LT307 Lavatory shipped with incorrect wall mounting bracket

Models Affected

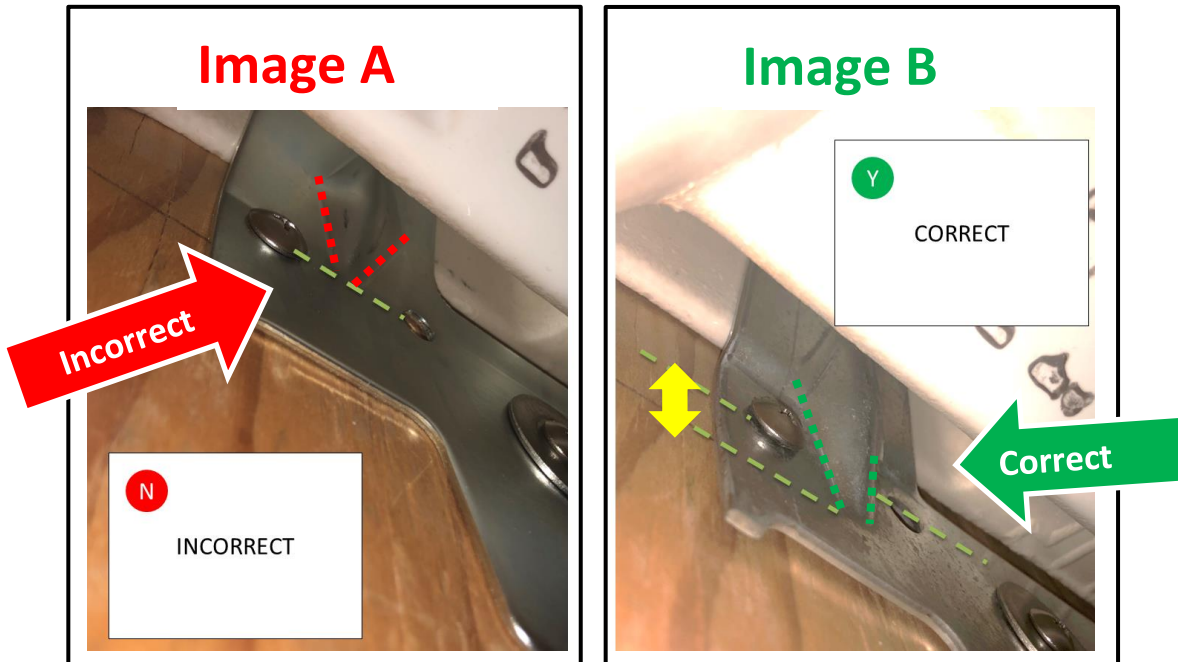
Q: How do I know if new inventory from TOTO USA has the correct wall mounting bracket inside the box?

A: If there is blue dot on the product label then the wall mounting bracket in that box is correct. See the example below.
